Model: CDP-C235
CDP-C335

Subject: Motor Drive Circuit Modification

Model: **CDP-C235, CDP-C335, CDP-C435, CDP-C535** **No.** **365R1**

Subject: **Part Number Missing - Reference No. -, Main Chassis** **Date:** May 15, 1996

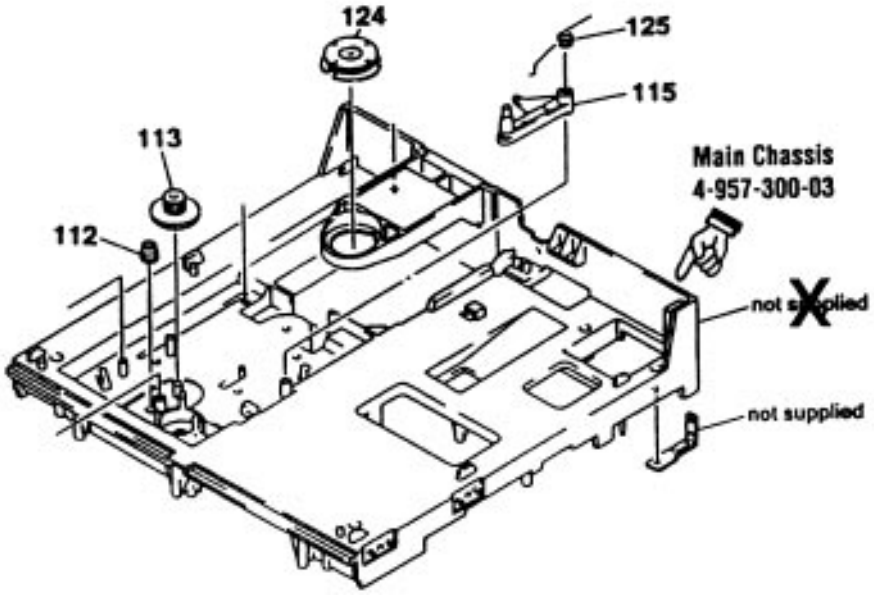
(**) The part number for Ref # -, Main Chassis, which is shown on page 23 of the Service Manual, is not listed in the parts list.

Solution: Please add the following part number to the Service Manual.

REF	DESCRIPTION	PART NUMBER
-	MAIN CHASSIS	4-957-300-03

Subject: Preventing Shipping Damage When Repaired Units Are Returned To Customers. **Date:** August 31, 1993

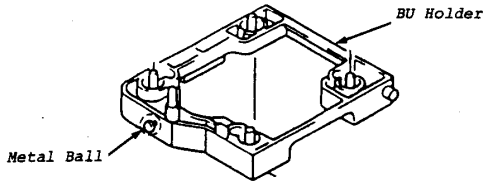
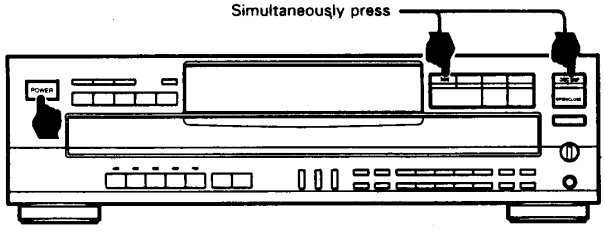
(62) Shipping damage may occur if the BU holder is not set to the "up" position before packing the unit. Typically, the metal ball attached to the BU holder becomes dislodged from the U/D gear if the unit is dropped during shipping.

Solution: Prevent shipping damage by making sure the BU holder is set to the "up" position before packing the unit. To do this quickly...

- Simultaneously press the reverse AMS button and Disc Skip button.
- Turn on the power while keeping the buttons pressed.
- When the words "NO DISC" appears on the display, turn off the power.
- The unit can now be shipped safely.

Page	Incorrect	Correct
13

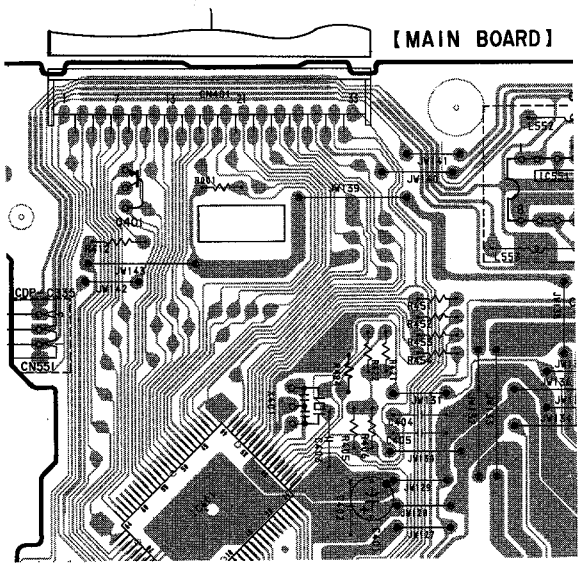
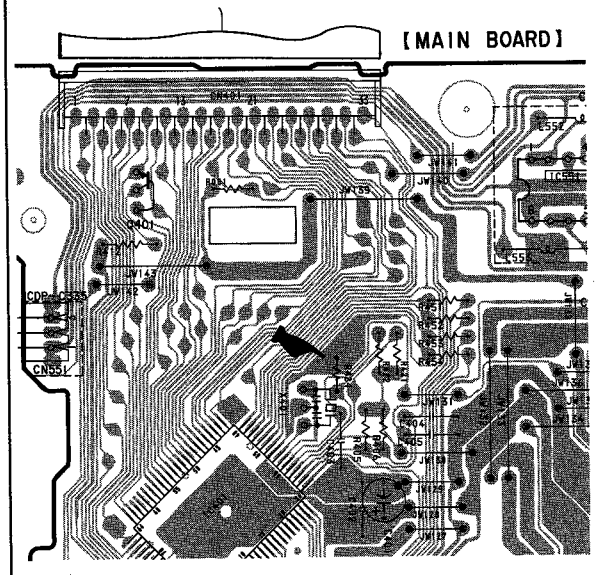
CORRECTION

23

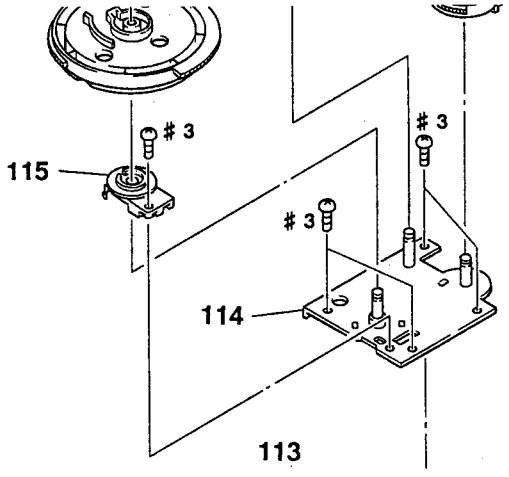
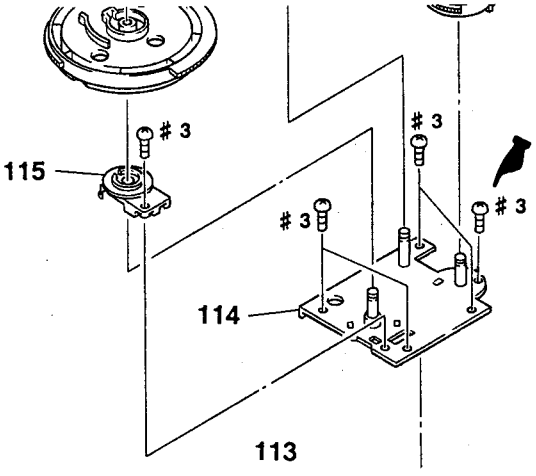
121 4-958-593-01 SPRING (BU), COMPRESSION	121 4-948-503-01 SPRING (BU), COMPRESSION

Subject : Positioning the Encoder When Attaching the Gear (MAIN)

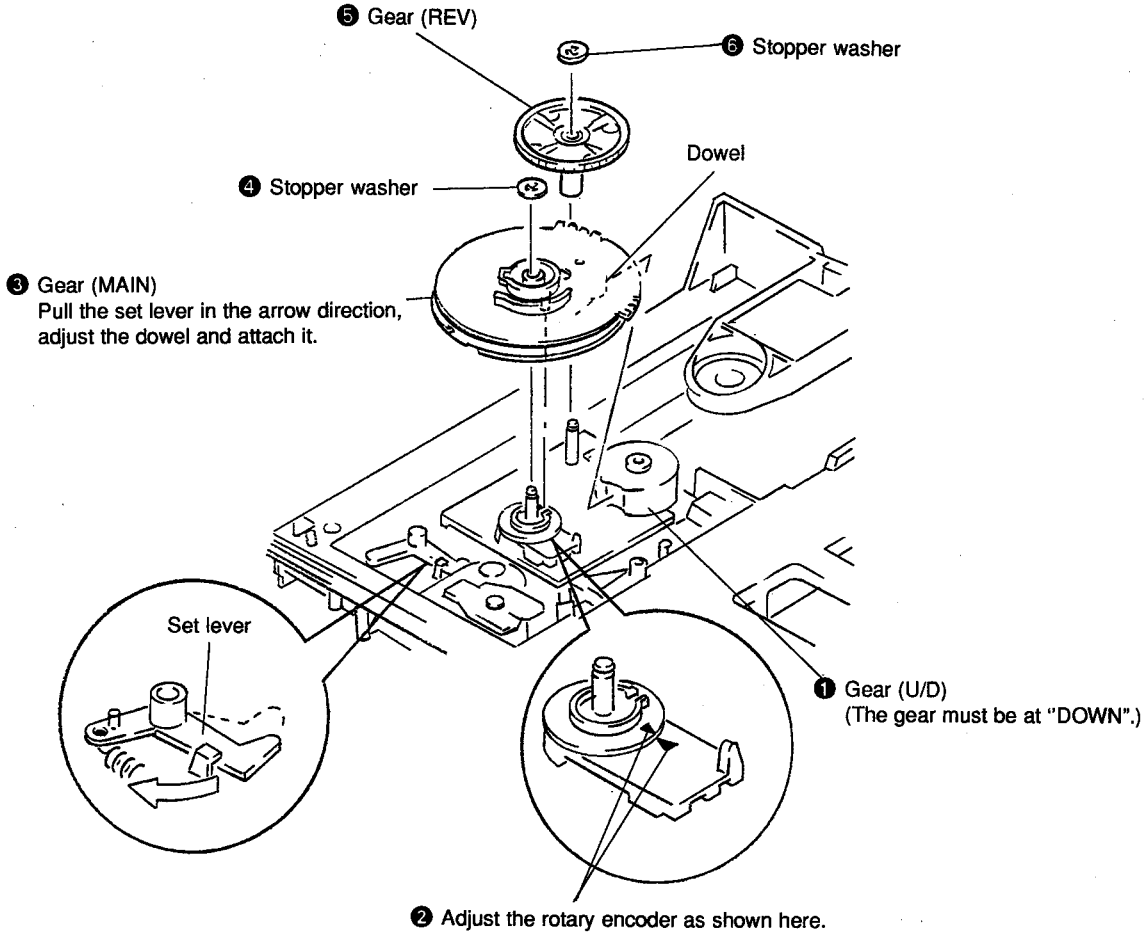
The position of the rotary encoder must be adjusted when attaching the gear (MAIN). If its position is not adjusted properly, problem may occur afterwards during operation.

6-3. CHASSIS ASSEMBLY (Page 23)

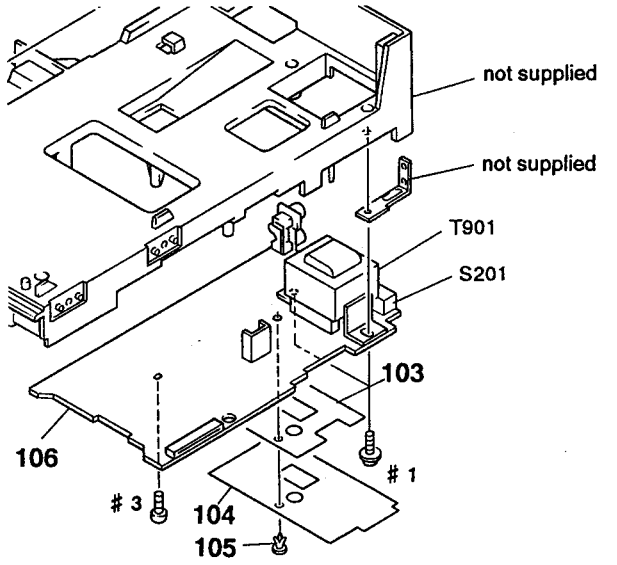
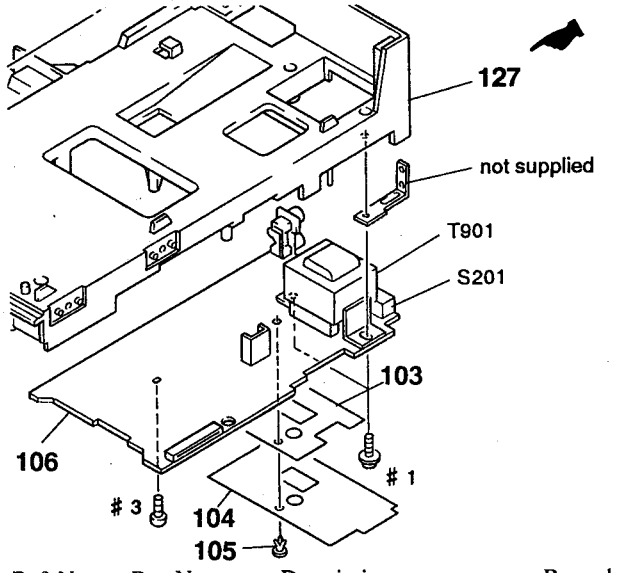
Incorrect

Ref. No.	Part No.	Description	Remark
* 127	4-957-300-03	CHASSIS ☛

Subject: **Substitution for KSS-390A** **Date:** June 14, 1996

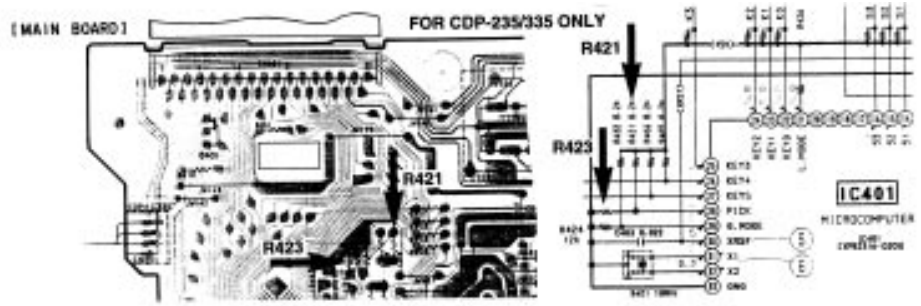
(**) The Optical Block KSS-390A is no longer available and KSS-240A is supplied as the substitution. As the two parts have some electrical and mechanical differences, please perform the following changes according to the model being serviced.

1. Check the value of R421. If it is 8.2KΩ or less, leave it in circuit. Otherwise, remove it and replace it with a jumper wire.
2. Confirm the existence of R423. If it is mounted, remove it. This is needed to keep pin 28 of IC401 High when operating CD function.
3. Replace the flat wire which connects the BD Board and Optical Block with the new type listed below.

Just replace the flat cable with the new type. No circuit modifications needed.

Description	Part Number	Note
Flat Cable	1-575-001-11	This cable must be used with KSS-240A
